SUNDRY NOTICES AND REPORTS ON WELLS form for proposals to drill or to deepen or reentry to a d	UCT 20:94
Do not use this	form for proposals to drill or to deepen or reentry to a d Use "APPLICATION FOR PERMIT—" for such proposals	ifferent resorvoir.

McIntyre A #10 990 FSL 2310 FEL Sec 20 T17S R30E Eddy County, New Mexico

## Plugging Procedure

### Current well bore diagram attached:

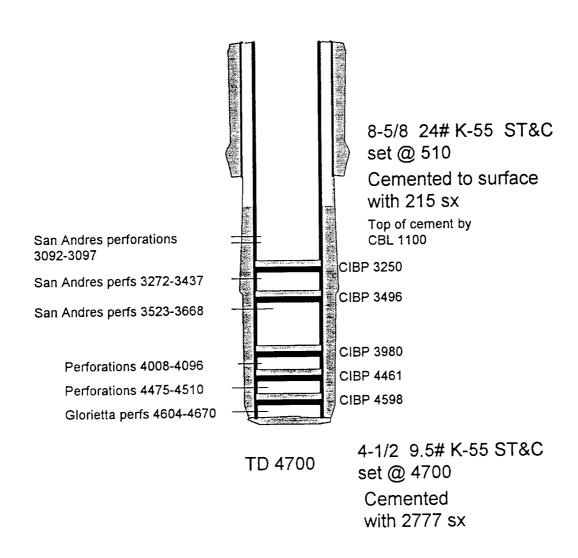
ABOVE CHAMBES MADE FOLLOWING TELECON WIGARY STITH 0H 10-18-94.

ALL CIBP HAVE 30 FEET OF CEMENT ON TOP
